310 - 326 Hale Road, Wattle Grove
Proposed Mixed Use Development

TRANSPORT IMPACT ASSESSMENT

Proposed Site Plan

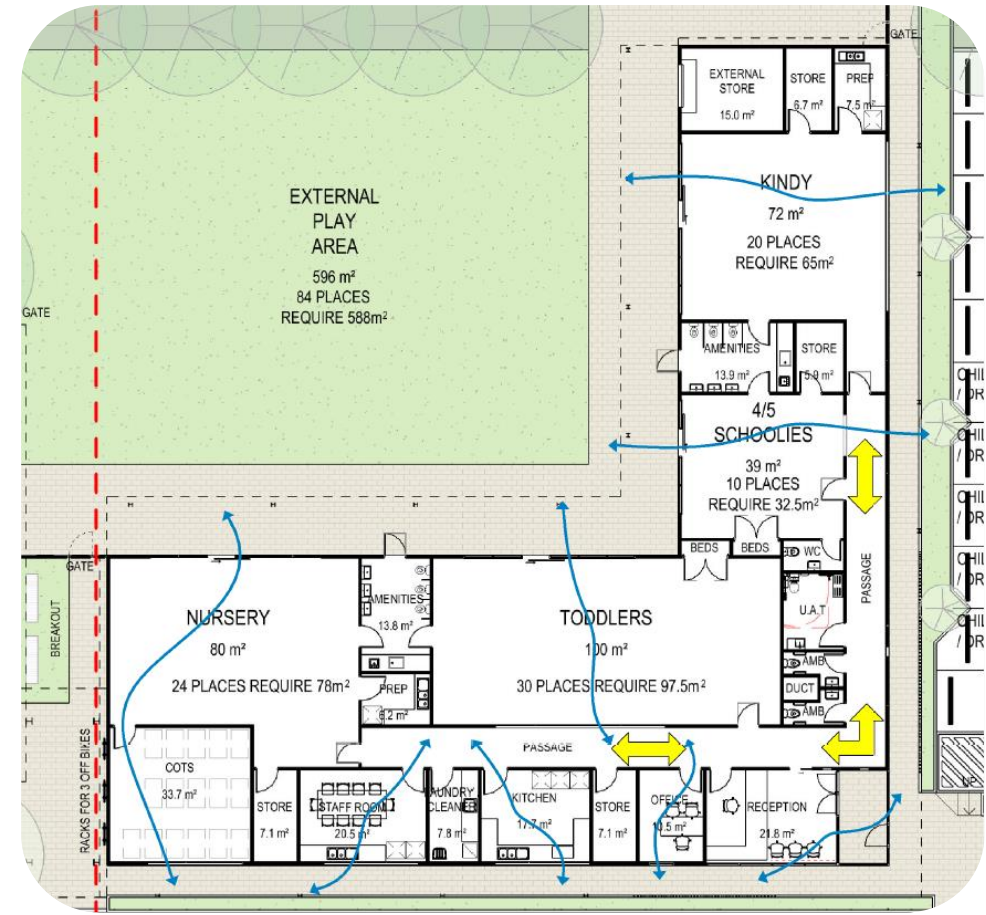
DAC COMMENT:

DESIGN RESPONSE:

6. Fixed louvre fencing and gate introduced between childcare external play area and communal breakout space; louvre blades strategically angled to allow light through but will limit visibility into childcare centre.

7. All footpaths have been widened to accommodate wheelchairs and prams – refer dimensions on plan drawings.
8. Bicycle parking location and type have been rationalised to prevent obstruction of footpaths.
